APPLICANT: Alabama Power Company
FACILITY: Joseph M. Farley Nuclear Plant, Unit 2
SUBJECT: SUMMARY OF OCTOBER 30, 1980 MEETING REGARDING REVIEW OF
OPERATING LICENSE APPLICATION

OCTOBER 30, 1980 MEETING
ALABAMA POWER COMPANY - NRC
OVERCURRENT PROTECTION

PROTECTION ANALYSIS FOR
RESPONSE TO NRC STAFF POSITION 040.15
CONTAINMENT PENETRATION OVERCURRENT PROTECTION
J. M. FARLEY NUCLEAR PLANT UNIT 2

FIGURE 12

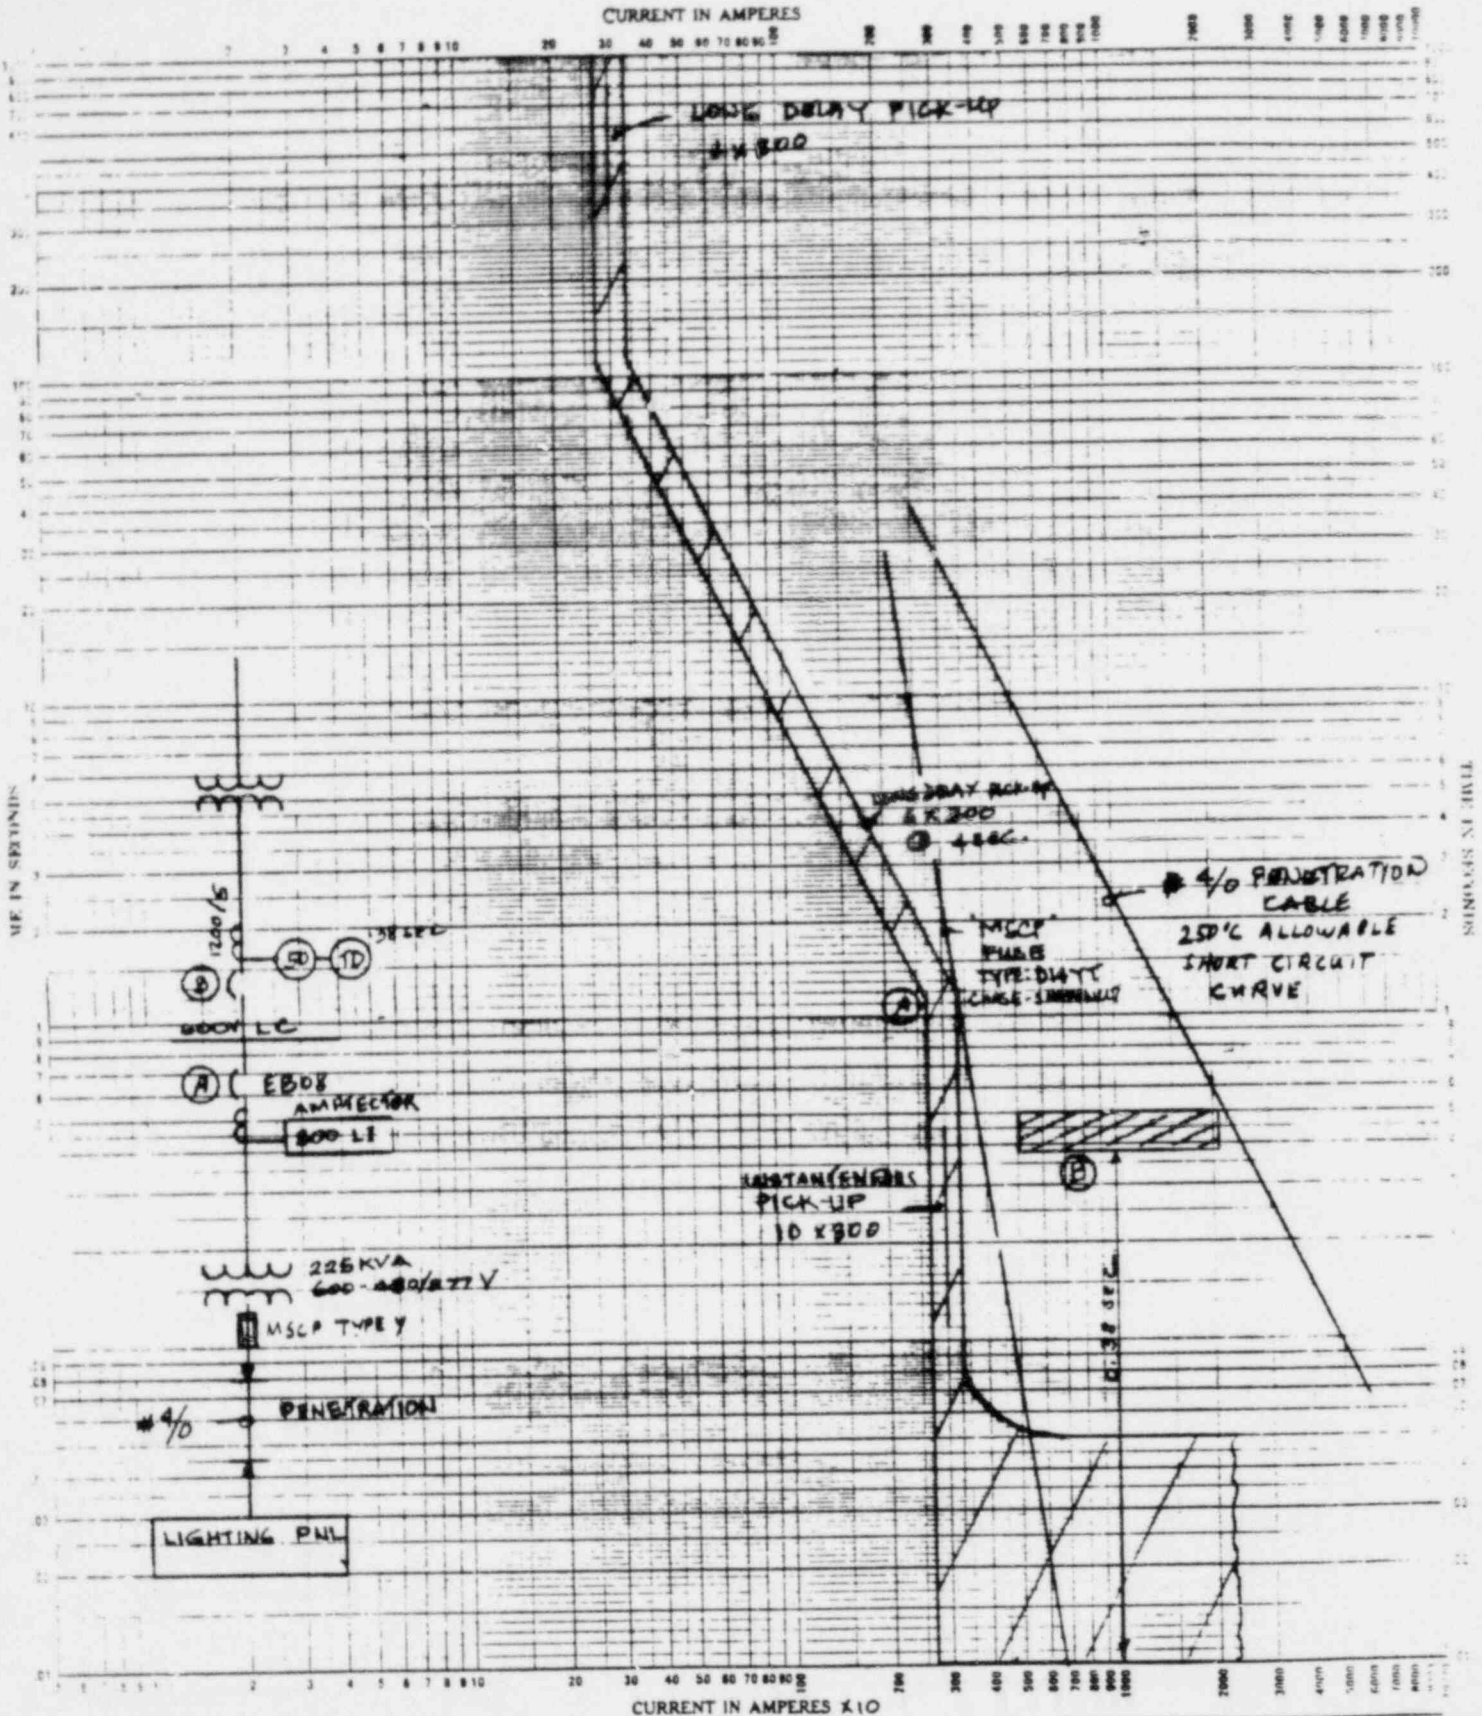
As shown on Figure 12, adequate primary short circuit and overload protection is provided for the containment penetration conductors by the existing 600V AC load center feeder breaker. However, as the 600V AC load center supply breaker is a magnetic trip only breaker, no backup overload protection is provided by the 600V load center supply breaker. A modification will be made to add MSCP fuses between the 225 KVA lighting transformer and the penetration conductors. As shown on Figure 12, the MSCP fuses will provide adequate short and overload backup protection for the penetration conductors.

FIGURE 13

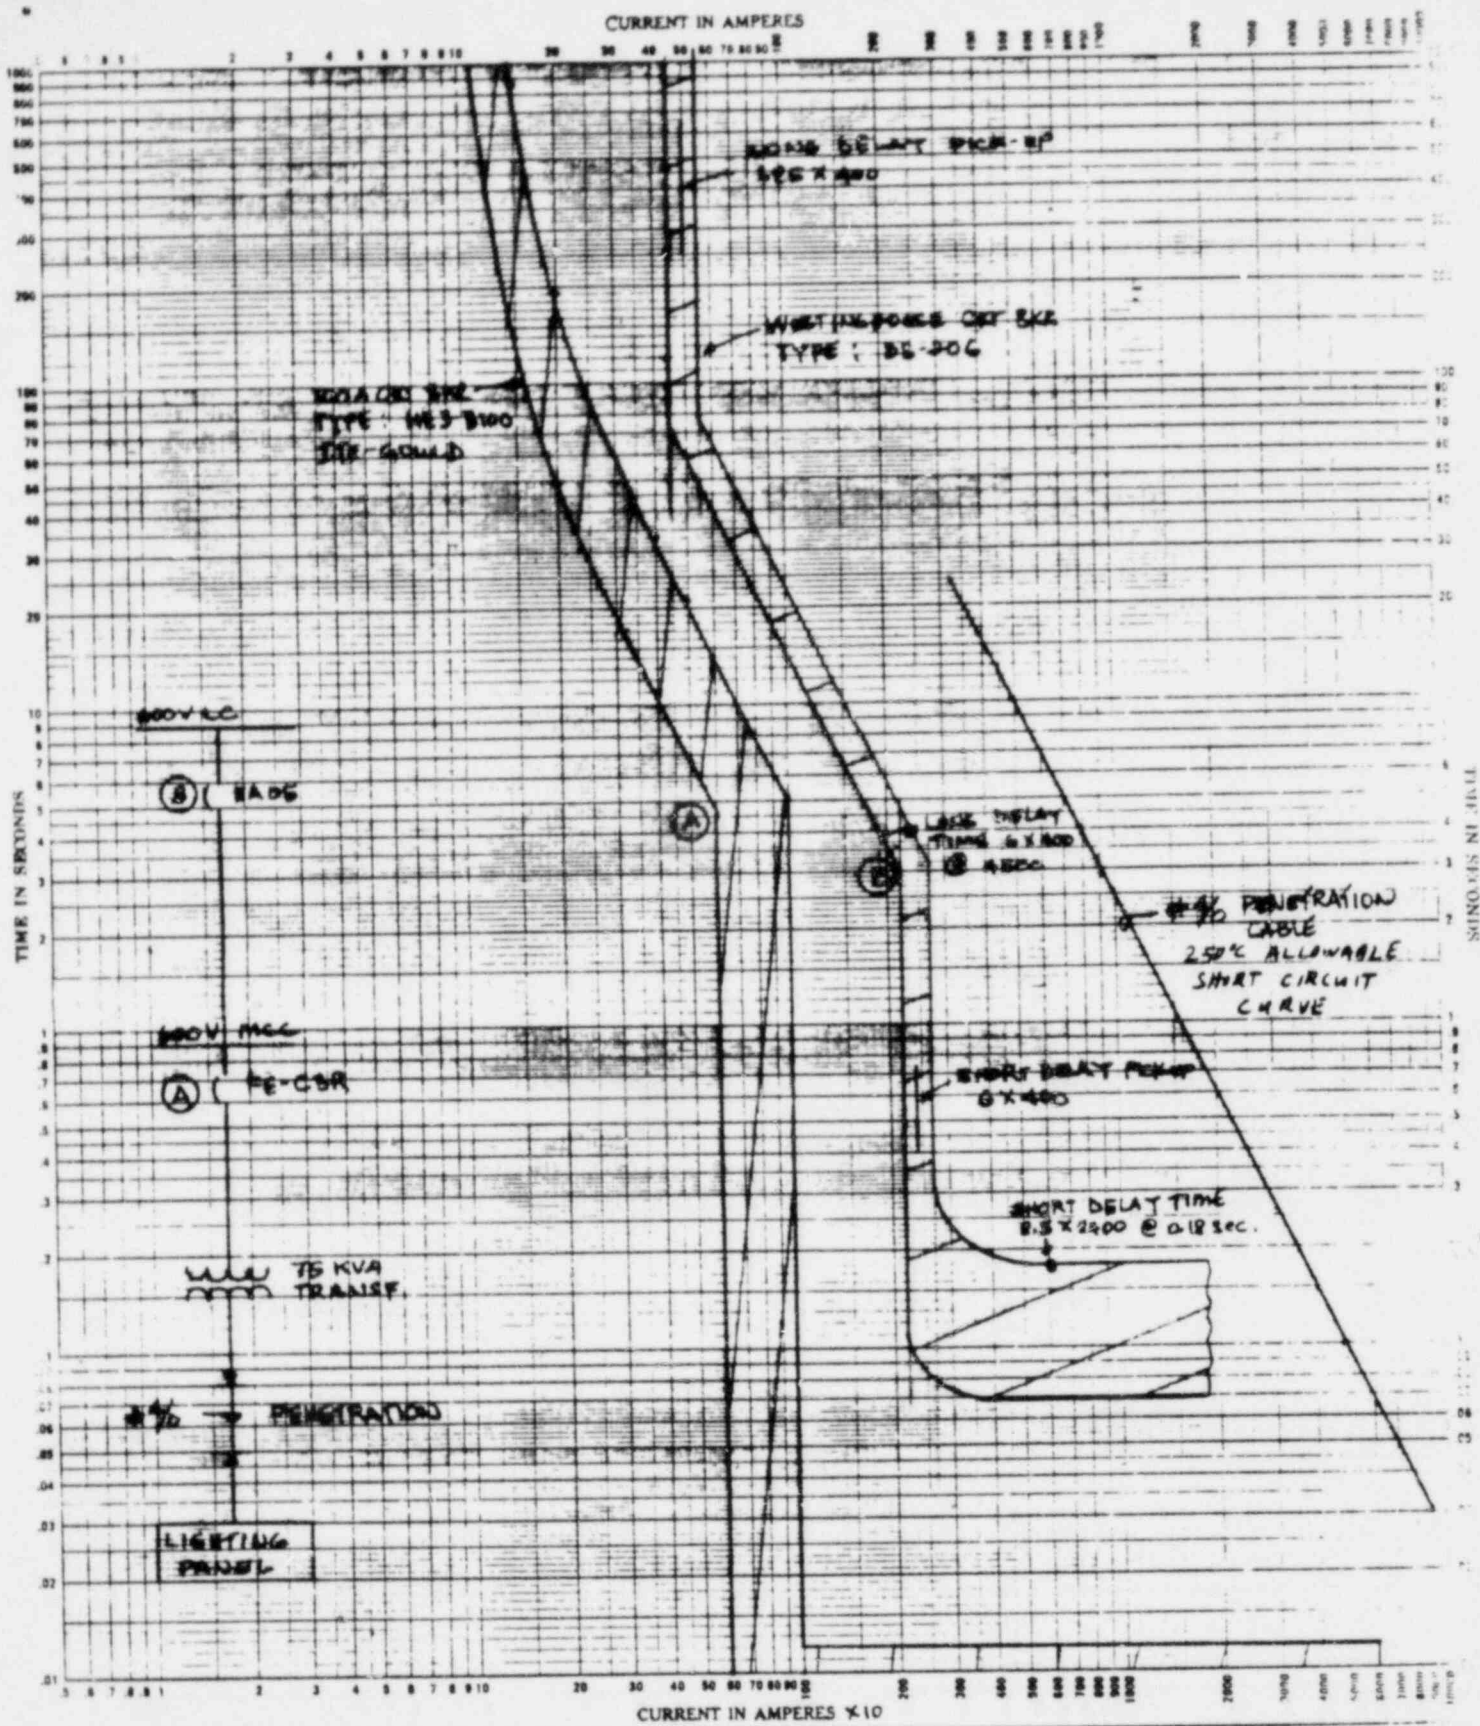
As shown on Figure 13, adequate primary and backup overload and short circuit protection is provided for the containment penetration conductors by the existing 600V AC MCC breaker and the 600V AC load center feeder breaker which supply power to the 75 KVA lighting transformer.
